Amendments to the Drawings:

Title: HEAT EXCHANGER AND PLATE USED IN A HEAT EXCHANGER

Appl. No.: 10/566,647

Fig. 1

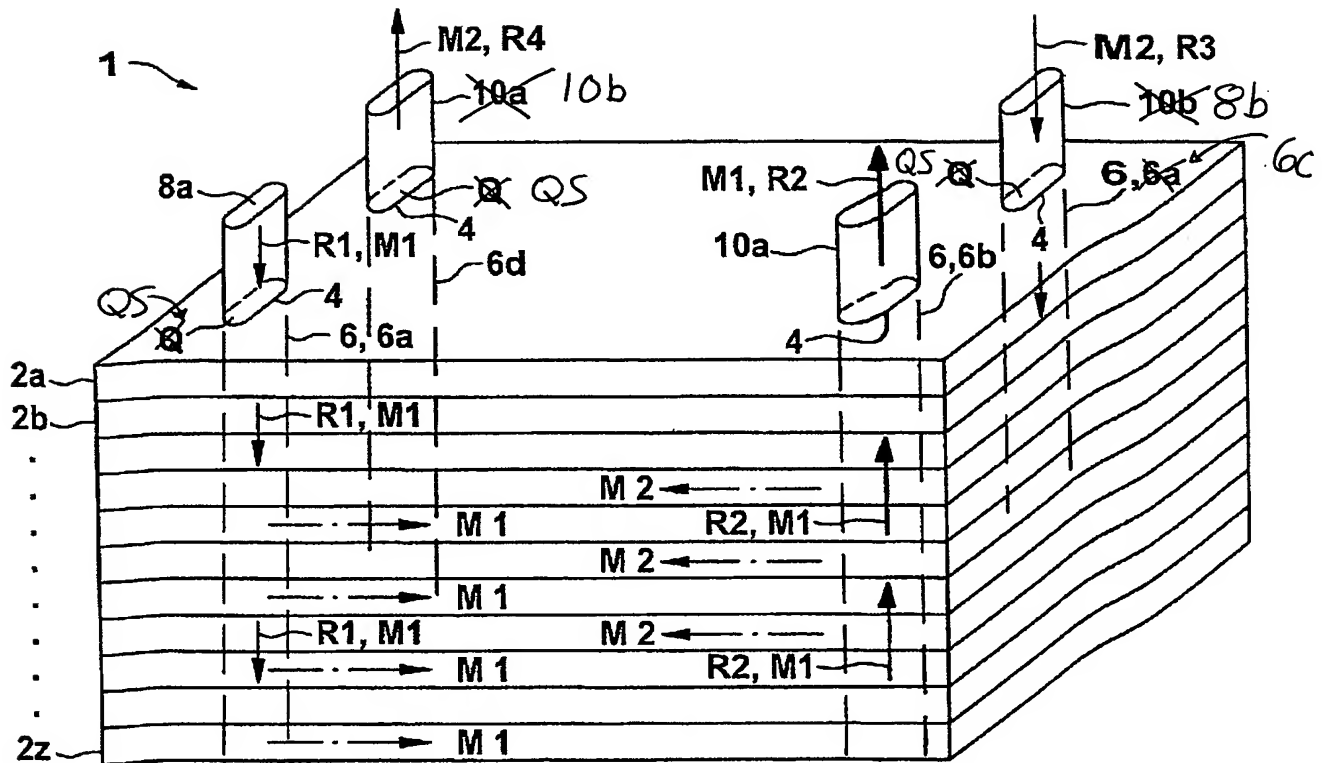
The specific changes which have been made to Figure 1 are: (1) reference character "10a" located near "R4" has been changed to "10b"; (2) reference character "10b" located near "R3" has been changed to "8b"; (3) reference character "6a" located near "R3" has been changed to "6c"; and (4) the three occurrences of reference character "Q" have been changed to "QS".

Fig. 2b

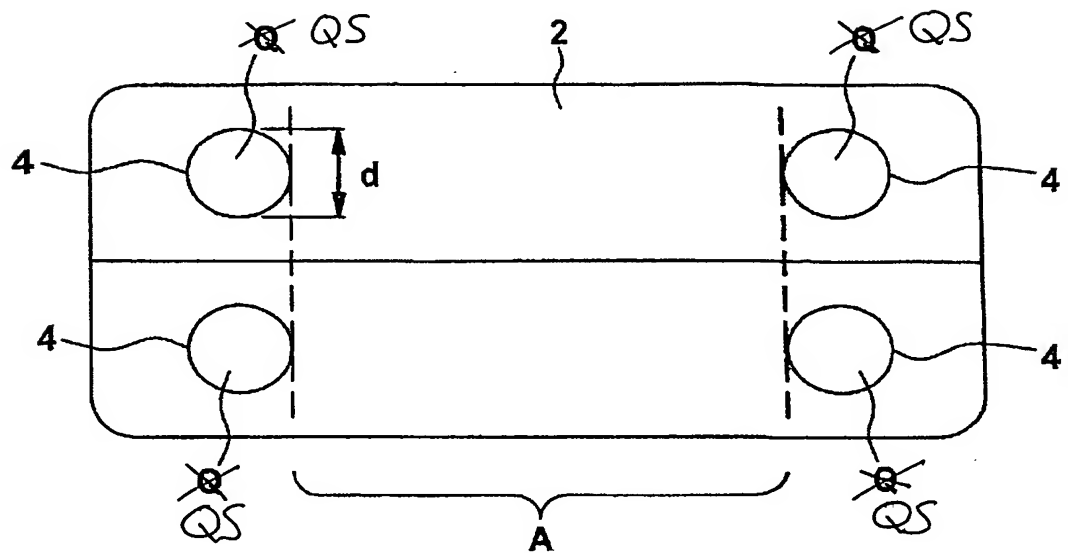
The specific changes which have been made to Figure 2b are the four occurrences of reference character "Q" have been changed to "QS".
